City of Brisbane

Planning Commission Agenda Report

SUBJECT: **23 San Bruno Ave.;** Use Permit UP-2-15 and Design Permit DP-1-15 to allow for the construction of an approximately 31-foot high, three-story, mixed-use building, including four 1,250 sq. ft. to 1323 sq. ft. residential units on the second and third floors and an approximately 550 sq. ft. ground floor commercial space and ground floor parking, to replace the existing single-story commercial building on a 5,000 sq. ft. lot in the NCRO-2 Neighborhood Commercial Retail Office Zoning District; Joseph J. Railla, applicant; Lon Carter, owner; APN 007-223-080.

JOB NO. 1501
 SHEET NO.
A-3
 OF 7 SHEETS

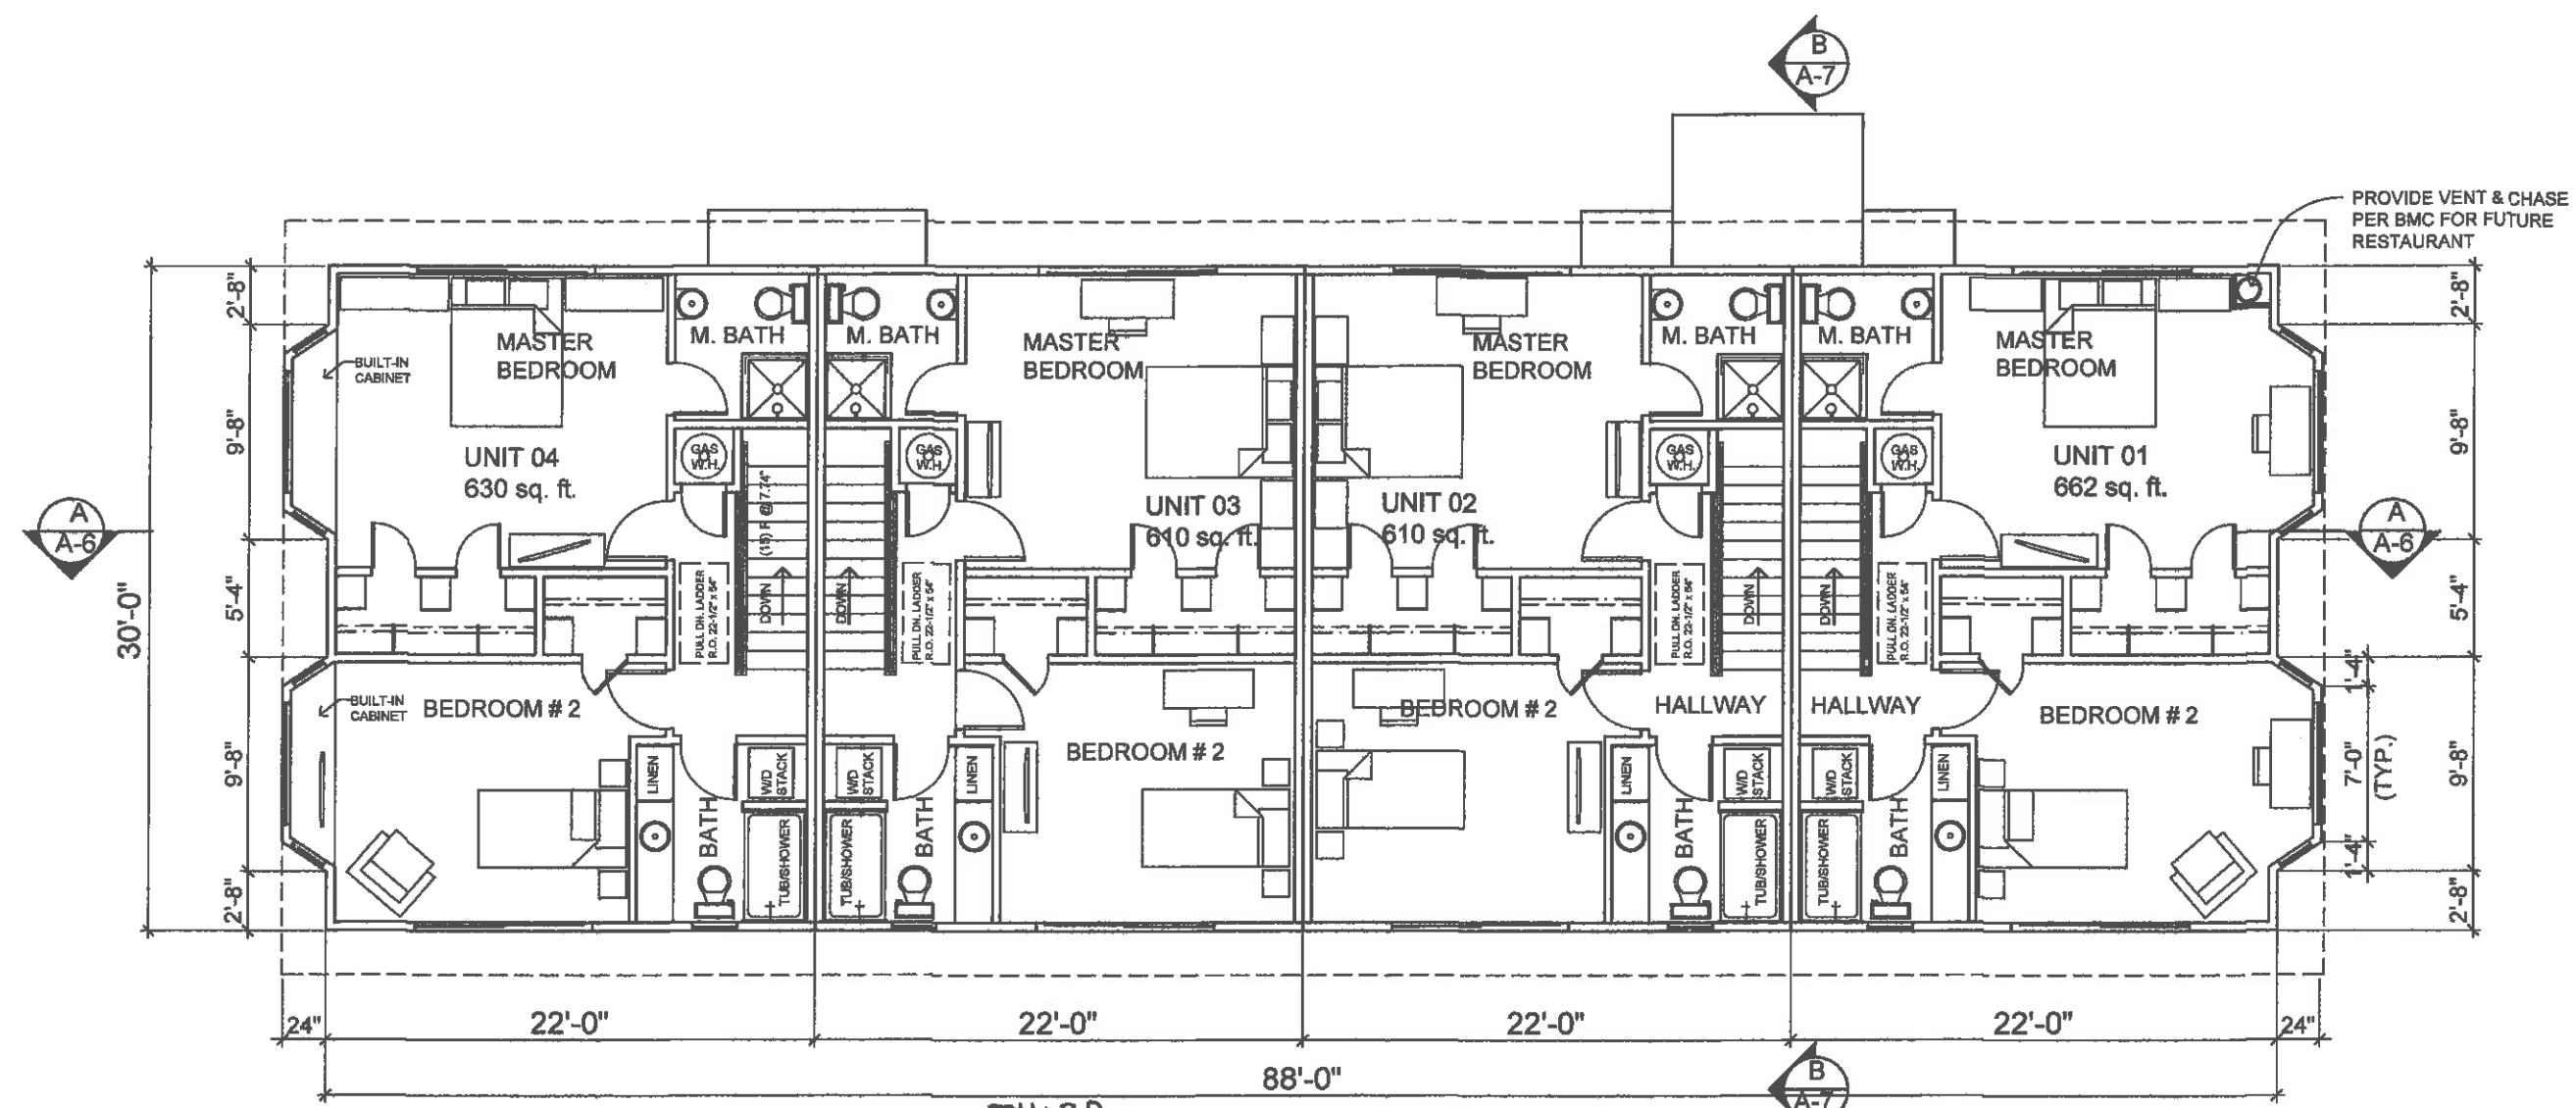
Despite the allowance for 90% of the site to be covered by the building, the application provides for landscaping on both the ground plane and at the first floor residential level that significantly adds to the landscaping and provides for passive recreation areas and would serve to create inviting and attractive spaces. While the code specifies a minimum of 60 square feet of passive open area per residential unit, the proposal includes between 274 square feet and 364 square feet of private garden/balcony area per residential unit. The plan calls for fruitless Olive trees, a very low water use species, to be planted in pots at the first floor level and additional potted plants may be added by the individual tenants. For further details on the plantings at that level refer to sheet A-3.

CARTER BLDG.
 EXTERIOR ELEVATIONS

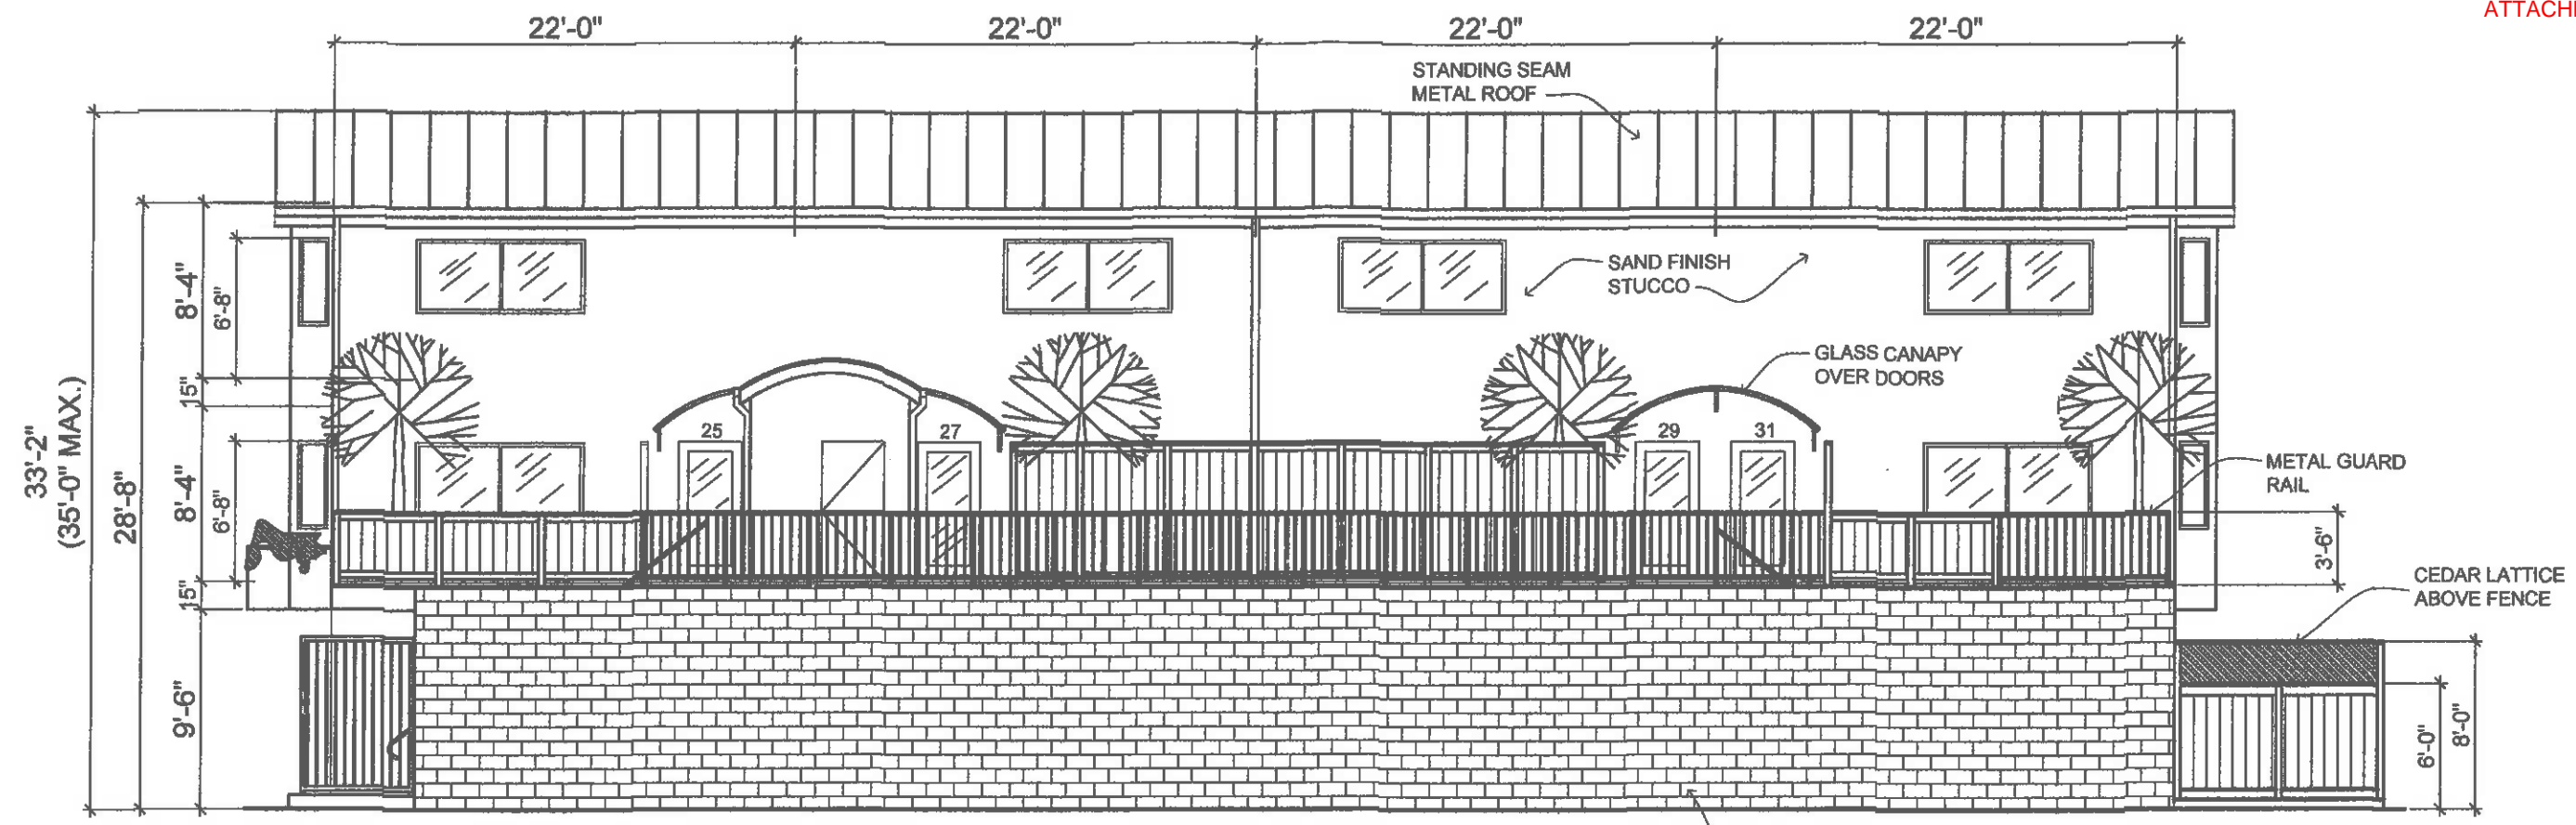
1. For the stucco, staff recommends a color change to have a darker more vibrant stucco color (trading the trim and stucco body colors), to further strengthen the pairing of the stucco with the subway tile (please see the material samples and renderings).
2. For the subway tile, it's recommended that that tile pattern be extended across the exposed edge of the second floor concrete slab to tie these sections in with the first floor materials.
3. That portion of the balcony level guard rail at the front of the site, which is proposed to be wood, should be stucco to match the body of the building on the second level.

- m. Plans shall indicate that no reflective exterior equipment shall be allowed. Roof vents shall be painted to match or blend with the rooftop.
 - n. Either the darker color muted orange shown in the application for the awning or similar color may be used for the stucco areas, instead of beige. The trim is to be either the lighter sand color or a darker color to contrast. Final color selection shall be subject to Planning Director approval following submittal of samples.

- o. That portion of the balcony level guard rail proposed in the applicant's plans to be wood shall be stucco instead (to match the body of the building), with its top cap to match the trim at the eaves.

- p. The grey subway tiles shall be extended to provide a covering for the exposed concrete band that appears over the entrance to the parking garage and over the pedestrian entry gate on either side of the commercial space.
